Model: <b>Soleil-PJ1a/Soleil-PJ1b/Soleil-PJ2/ Altair-PJ1/ Altair-PJ2/Soleil-PJ2.5</b>	Date: 19-Oct-12	No.: RY011003f
---	-----------------	----------------

Subject: Firmware Release Note: Backup Tool		Prepared by: A. Iwaori	
From: VC Products Support Sec., Solution Support Dept.			
Classification:	<input type="checkbox"/> Troubleshooting <input type="checkbox"/> Mechanical <input type="checkbox"/> Paper path <input type="checkbox"/> Product Safety	<input type="checkbox"/> Part information <input type="checkbox"/> Electrical <input type="checkbox"/> Transmit/receive <input checked="" type="checkbox"/> Other (Firmware)	<input type="checkbox"/> Action required <input type="checkbox"/> Service manual revision <input type="checkbox"/> Retrofit information <input checked="" type="checkbox"/> Tier 2

Model: Soleil-PJ2.5		Date: 30-May-16	No.: RY0A1003
Subject: Service manual revision: Keystone Calibration & Troubleshooting		Prepared by: Takuma. Sakakibara	
From: VC Tech Service Sect., MFP/Printer Tech Service Dept.			
Classification:	<input type="checkbox"/> Troubleshooting <input type="checkbox"/> Mechanical <input type="checkbox"/> Paper path <input type="checkbox"/> Product Safety	<inp

#### Step 4.

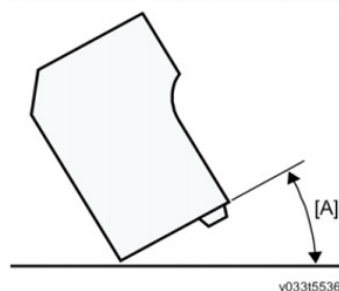
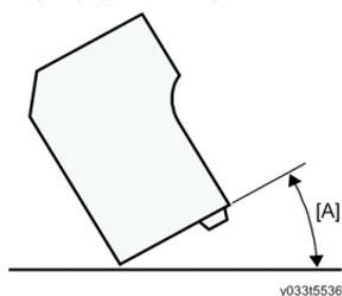
4. Keep the projector at 20 degrees.

[A] 20 degrees

**Wrong**

4. Keep the projector at **-30** degrees after removing the stand in the front of projector.

[A] **-30** degrees

**Correct**

#### Step 7.

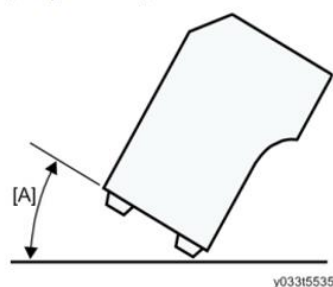
7. Keep the projector at -20 degrees after removing the stand in the front of projector.

[A] -20 degrees

**Wrong**

7. Keep the projector at **30** degrees.

[A] **30** degrees

**Correct**
